**OHIO DEPARTMENT OF NATURAL RESOURCES
DIVISION OF MINES AND RECLAMATION****APPLICATION TO REVISE A COAL MINING PERMIT**

THIS REVISION INCLUDES CHANGES TO THE REFUSE DISPOSAL PLAN -
RAISING NO. 2 SLURRY IMPOUNDMENT. SEE ADDENDUM TO ITEM 4

EMBANKMENT RAISING
NO. 2 SLURRY DAM

PROPOSED DECANT EXTENSION
DETAILS

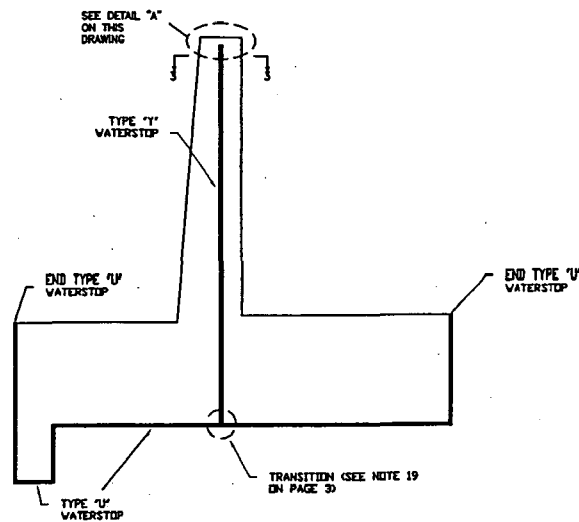
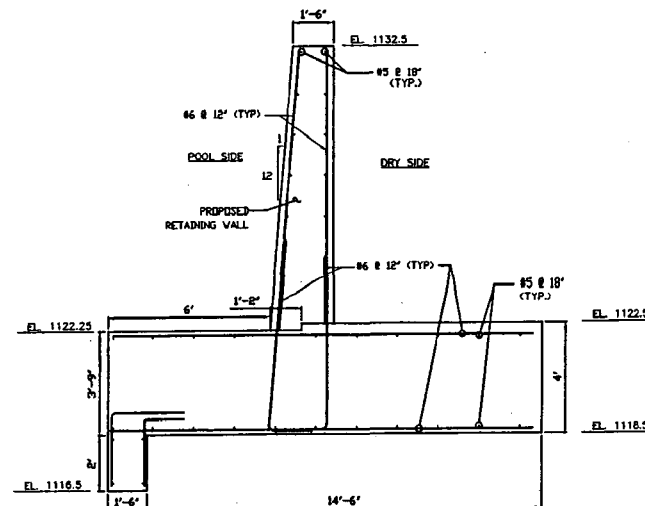
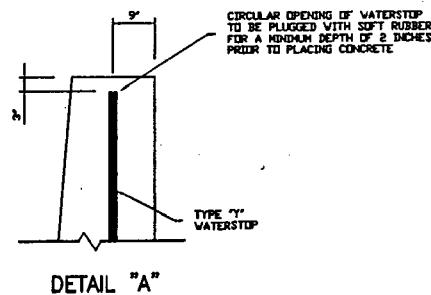
11. Provide more detail on the extension of the decant structure. Provide size, slope, material types, inlet details, pool elevation control structures, etc. Discuss how the proposed will be joined to the existing structure.

EMBANKMENT CROSS SECTIONS

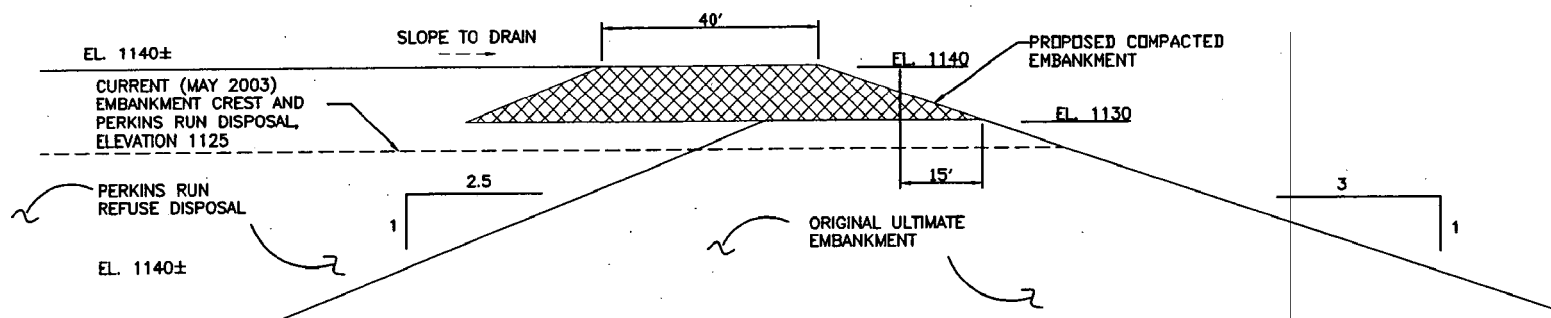
19. Verify width of spillway control sill, sheet 3. This shows a bottom width of 90', yet plan view shows 50'.
 - ▶ **The spillway and the spillway control section are 50-foot in width. The spillway control sill is 90-foot in width so that the sides will extend into the spillway sidewalls to act as a key to reduce seepage around the ends of the wall.**
